**City Planning Commission**  
**April 15, 2026, 5:30 PM**  
**Council Chambers – Hillsdale City Hall**

**To:** Planning Commission  
**From:** Zoning Administrator  
**Date:** April 15, 2026  
**Re:** Commercial Site Plan Review – Culver’s Hillsdale

**Re:** Preliminary Site Plan Review  
March 31, 2026, 11:00 AM  
Council Chambers – Hillsdale City Hall  
97 N Broad St, Hillsdale, MI 49242

**Project:** PZ2026-009  
3741 W CARLETON RD  
NEW ~ 4,703 SF RESTAURANT – CULVER’S HILLSDALE, MI

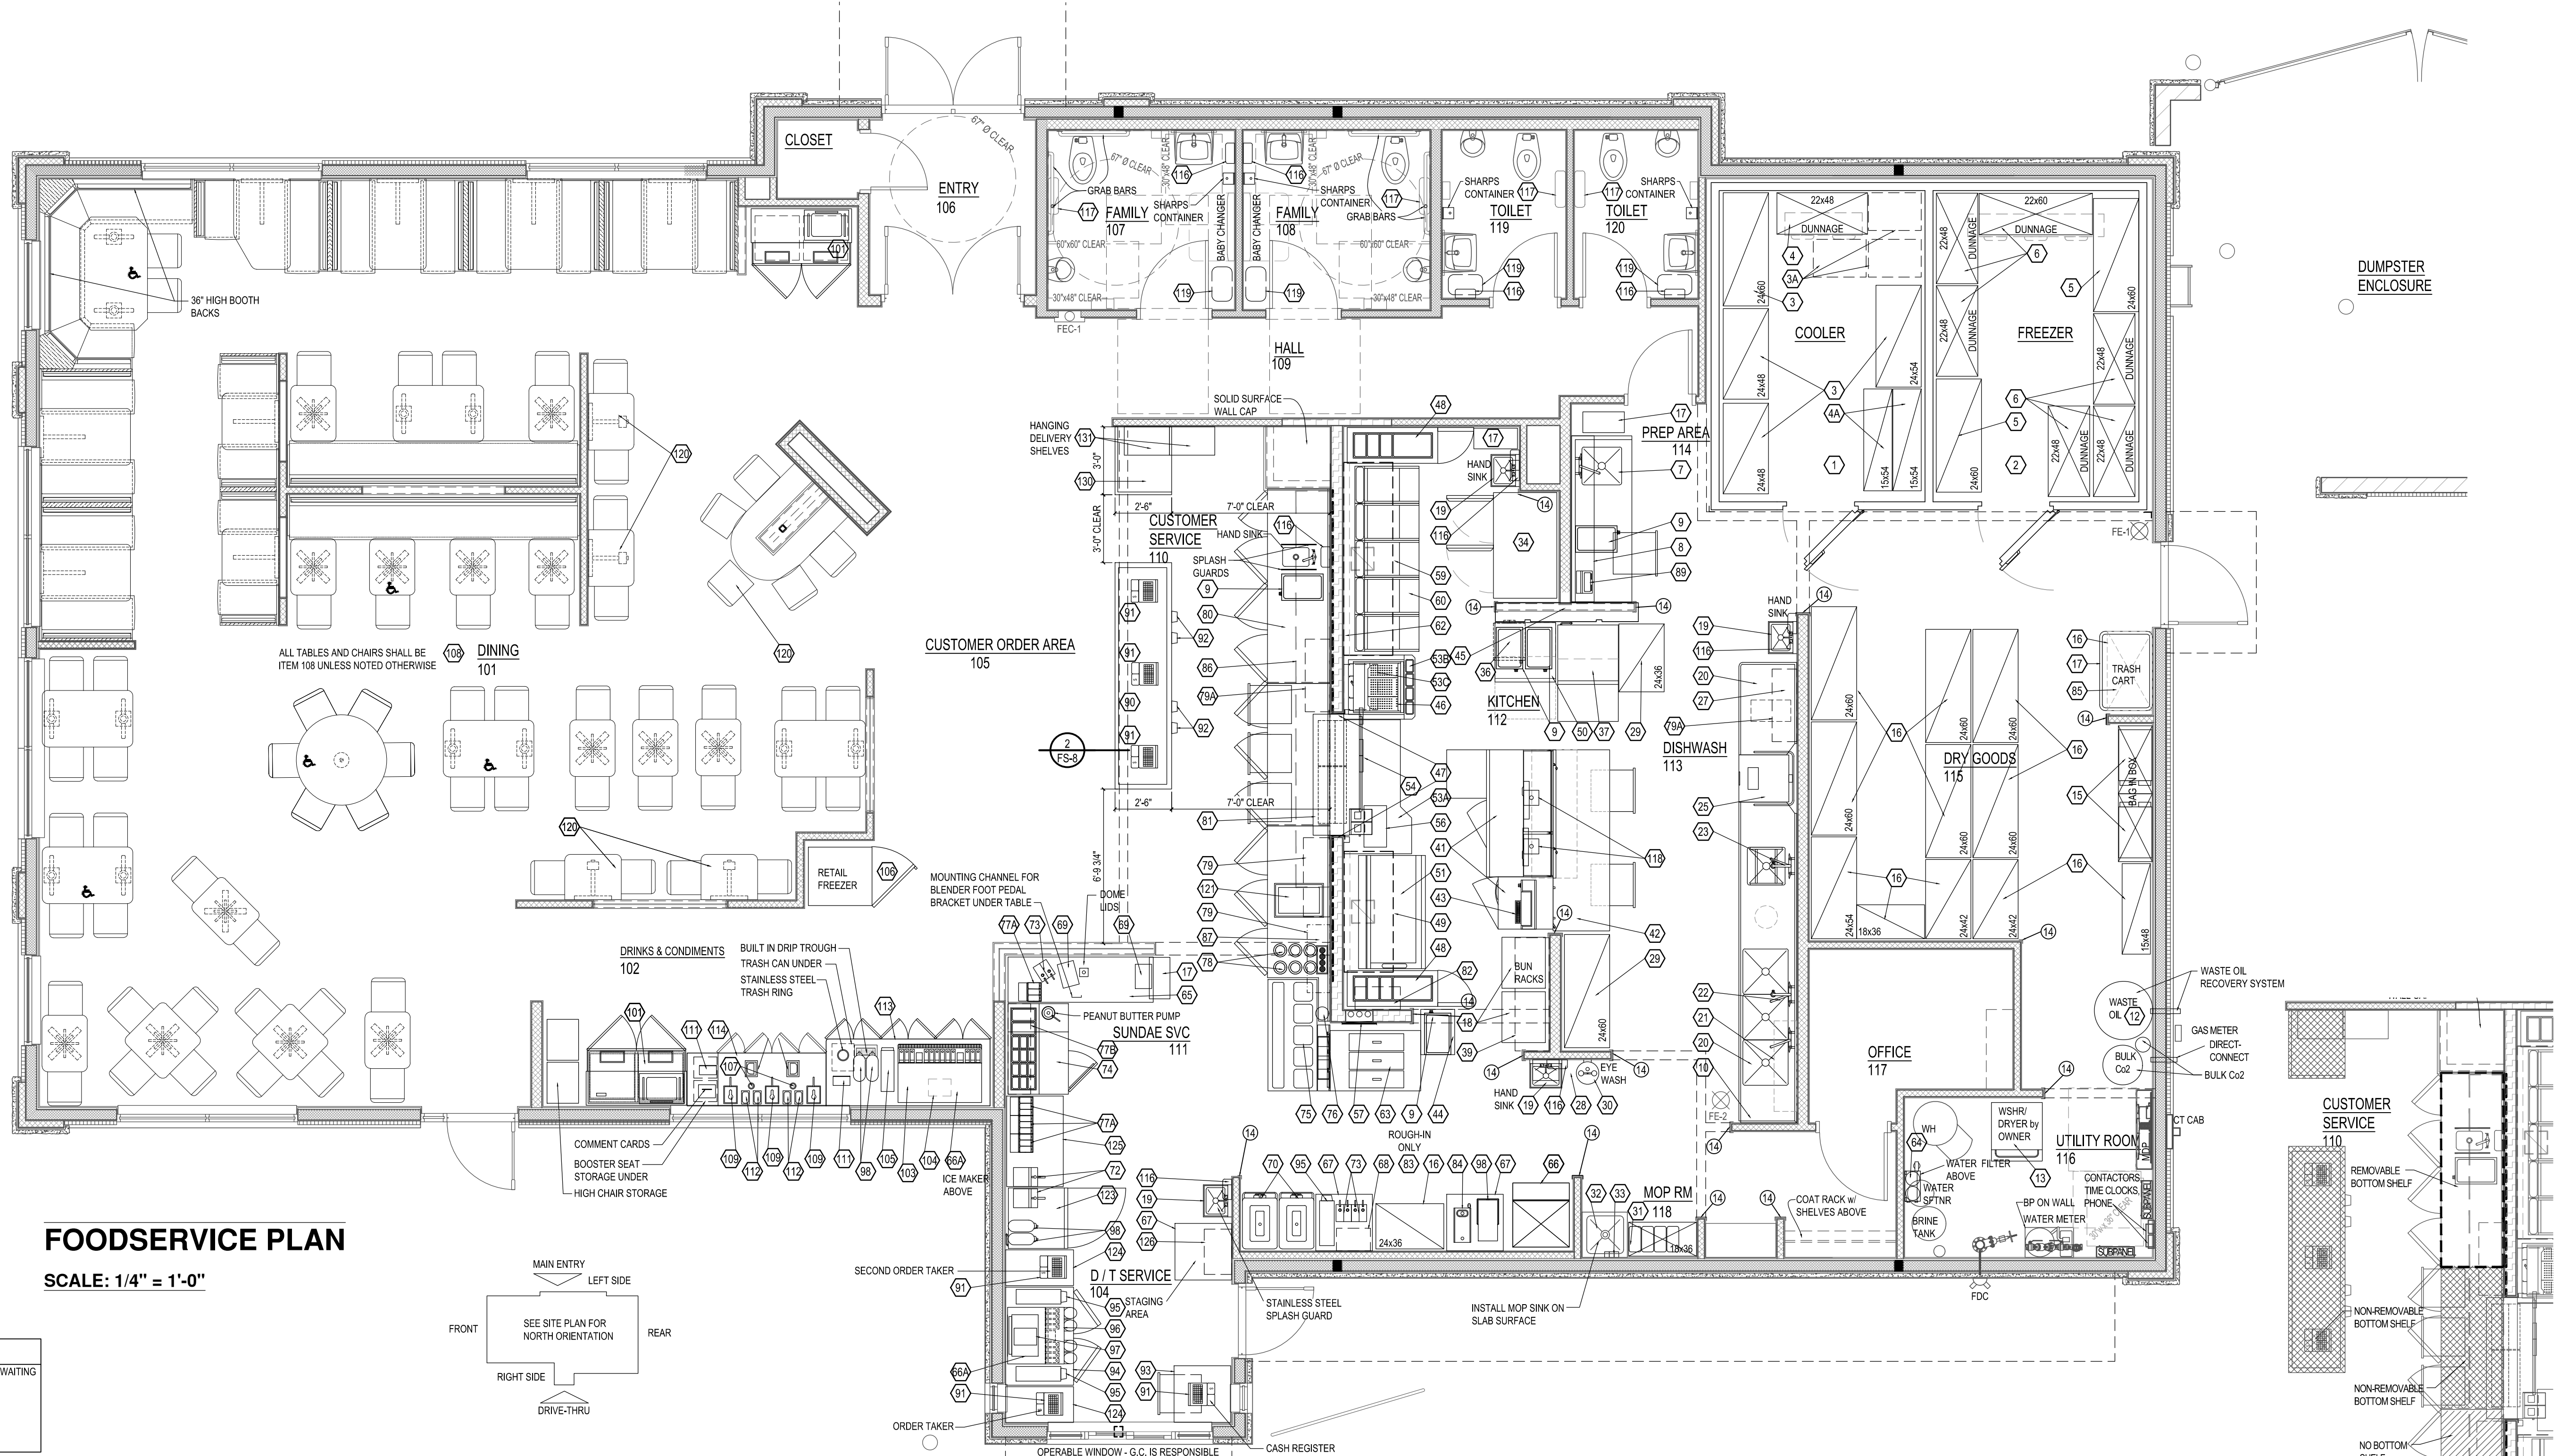
- Believes Stormwater Management Calculations are conservative. Specifically, the following rates found on C5.2:
  - $I_{100} = 9.21$  in/hr
    - Believes the rate could fall between 5.5 – 6 in/hour and allow the infiltration basin to be approximately 30% smaller
  - $K_{sat} = 5.00$  in/hr
    - Staff is aware of the note on the site plan regarding infiltration testing and updated numbers following the testing

- Specifications for the Fire Department's largest truck:
  - 2003 E-One Ladder 100' Cyclone GVWR 75,500
    - Bumper-to-Bumper Distance: 42'
    - Center of Rear Axle to Center of Front Axle: 22'10"
    - Width: 8'8"
    - Turn Radius: 35'– 40'
- Knoxbox required
